Reviewers' comments are given in **"bold"** font, our responses are written in "normal" font, and quotations from the revised manuscript are provided in *"italic"* font.

Figure 1. Groundwater Map

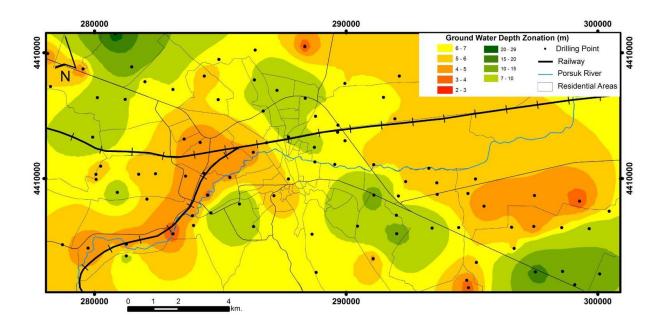
Only a general description of the groundwater table is given. More details are required as they are pertinent with the liquefaction phenomenon. Therefore, it is necessary to indicate the actual mean depth of the groundwater, especially in view of the fact that the authors have at their disposal a sufficient number of wells for this purpose.

Groundwater table (Figure 1) map will also be given in the final revised paper.

Figure 4. Study area of the Tosun et.al, 2011

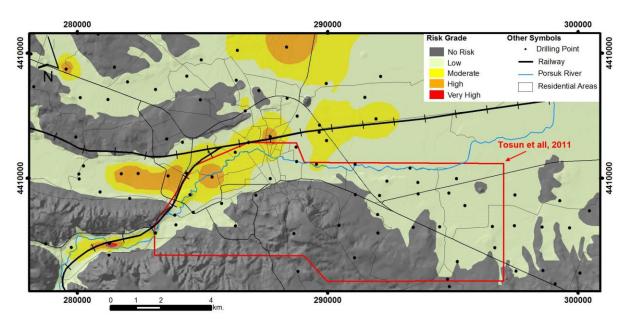
The authors perform the soil liquefaction analysis for Eskişehir city using Standard Penetration Tests (SPTs). The literature shows that a detailed and similar analysis was already performed for the same city and approximately for the same study area (Tosun et al., 2011). Therefore the authors, which apparently seem to be unaware of that paper, should compare their work with previously published research, highlighting differences, analogies and possible improvements of their research.

There is no scientific overlap with the liquefaction analysis that has been completed by Tosun et.al.2011. Most importantly, the study area of Tosun et al. covers only Odunpazari district, which is southern of Porsuk River while the present manuscript covers the entire Eskisehir districts. Therefore we have expanded the liquefaction area significantly as can be seen on Figure 4. The present data sets are also more resolved. Tosun et.al. employed shallow drill holes with a mean depth of 10 meters, while present study utilized 87 drill holes and calculations were made through 20 meters depth, according to Iwasaki et al. (1978, 1982). actually the depth of the drillholes are 30 m. In the revised manuscript Tosun et al. 2011 is cited referring to the above differences.

Figure 3. High Risk Seismic Regions: A area; high population with high seismic risk; Area B and C; significant population with high seismic risk and Area D; almost no population with very high seismic risk

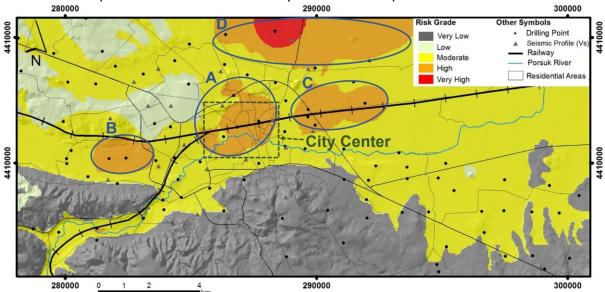
Furthermore, it is important to discuss the relationship between the findings of the authors and the current urban layout. For example, what conclusions emerge from the comparison between the most hazardous zones as derived from your study and the intensity of urbanization of Eski sehir city?

This is another good point and included in our revised manuscript. A vulnerability, defined as the expected degree of loss for an element at risk as a consequence of a certain event, is an important factor in a quantitative risk assessment. Vulnerability is highly dependent on the population and soil properties range of values for exposed elements at risk in the settlement area. In this study, the vulnerability was studied in 4 different high-risk seismic regions where varied in their degree of seismic risk for soil properties. We classify there regions in to four groups, A, B, C, and D, based on their population (Figure 3). Region A is located near the Porsuk river having both highest population and feature high story buildings that includes city center. Approximately 150K people live in this region. Likewise regions B and C are located outside of the city center but still have a significant settlement. The typical building in this region are 2 to 3 stores with relatively lower population (30,000) than Region A. Region D is located at the north of the city with almost no population. For these reasons, a vulnerability of region A is higher than other regions. The results of this study could be used for urban renewal plans. Prime Ministry Disaster and Emercency Management Presidency corps could use the results to determine the emergency plans before a possible earthquake and to find the places to be reached instantly after an earthquake.
